**ARBORICULTURAL IMPACT ASSESSMENT FOR 2022 DEVELOPMENT AT
21-25 NORTH PARADE WAGGA WAGGA NSW 2650.**

*DUKE OF KENT HOUSING PROJECT – 21, 23 & 25 North Parade, WAGGA WAGGA BLK: 56, 57, 58 DP: 21115. **OVERALL SITE PLAN – North Parade.** SK 114. Issue P1. Dated 12/03/2022. CK Architecture Deakin ACT.*

DUKE OF KENT HOUSING PROJECT
21, 23 & 25 NORTH PARADE, WAGGA WAGGA BLK: 56, 57, 58 DP: 21115

OVERALL SITE PLAN - NORTH PARADE

SK-114

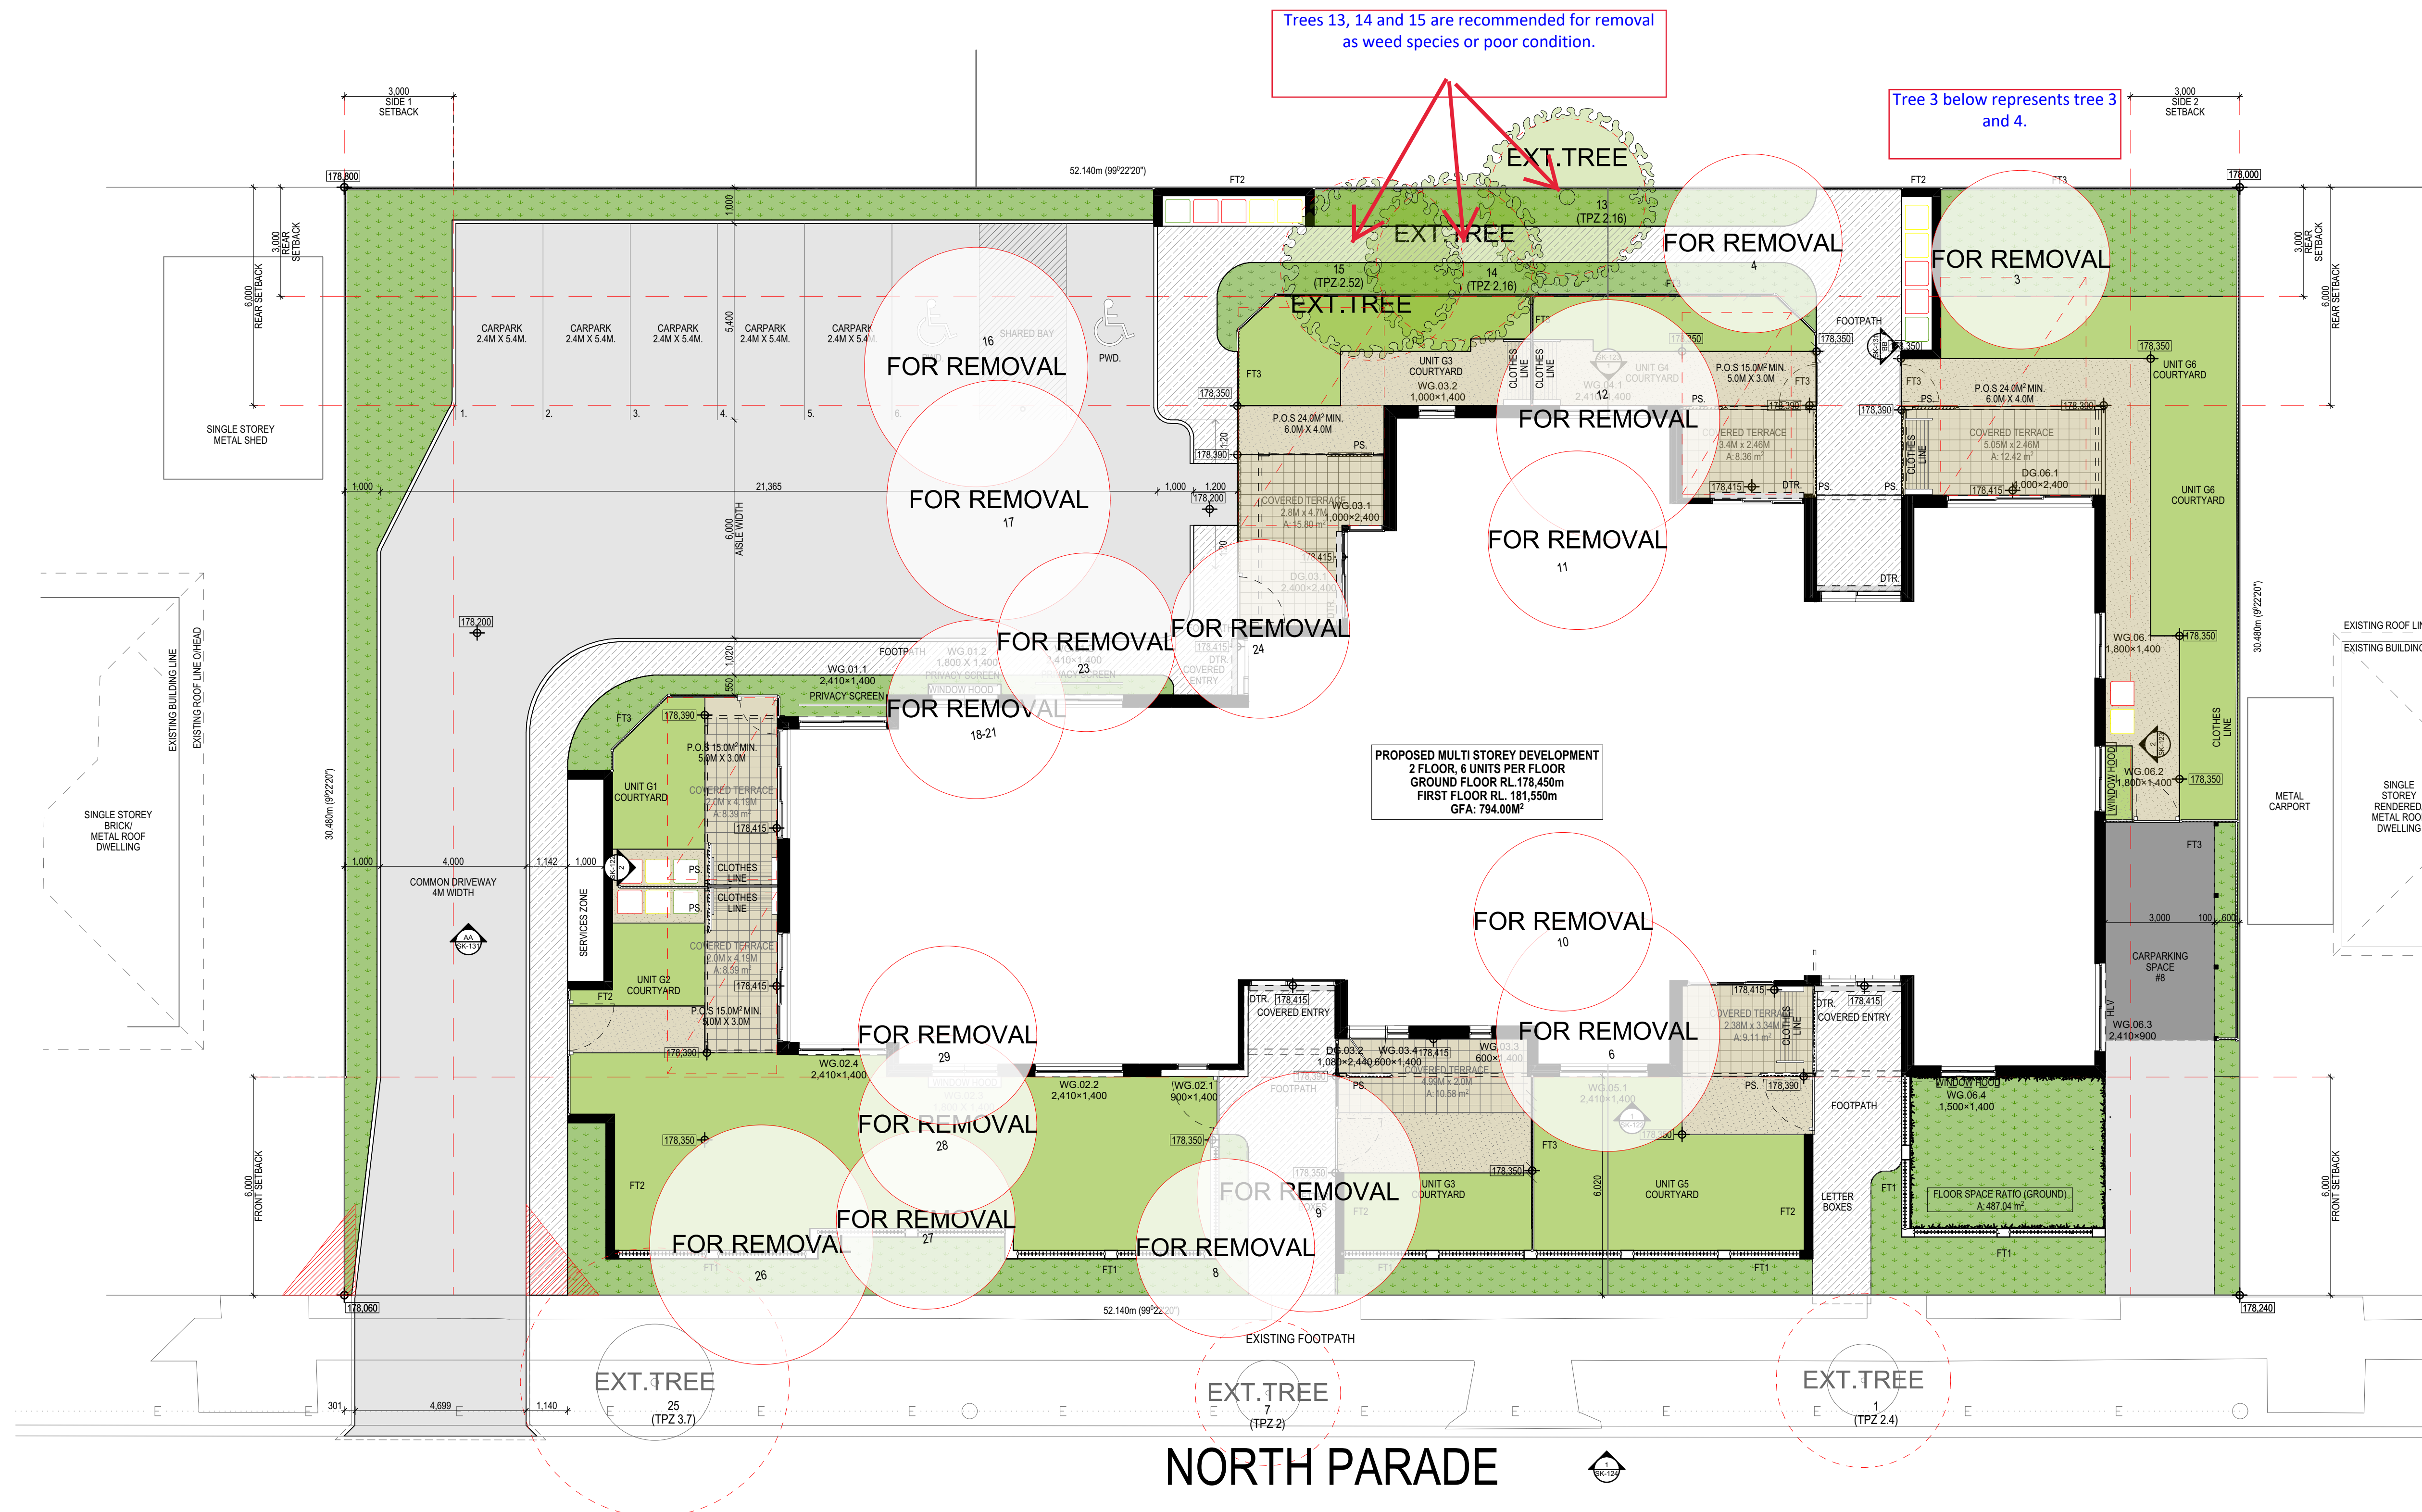
This drawing contains existing trees on site, trees for retention and removal. Tree Protection Zones (TPZ) are also detailed. Some comments have been added and the drawing is provided at the conclusion of this report.

- i. All trees excluding 1, 7 and 25 are identified/evaluated as *remove priority* or *remove*.
 1. These trees are mostly weed species, in poor condition or small trees.
 2. NOTE that Overall Site plan has trees 13, 14 and 15 as retained – it is strongly recommended that these trees are removed and the Overall Site Plan has been marked up with this recommendation.
 3. Whilst the canopy coverage loss is somewhat notable the species composition is mostly weeds that have established on site and need to be removed for environmental reasons.
- ii. Only 4 trees meet the criteria of tree preservation *WWCC Development Control Plan 2010 -PART B Section 5 Natural Resource and Landscape Management 5.2 preservation of trees*.
 1. Trees 6, 24, 26 and 29.
 2. All these trees are recommended for removal on the basis of poor condition or unsuitable for location.
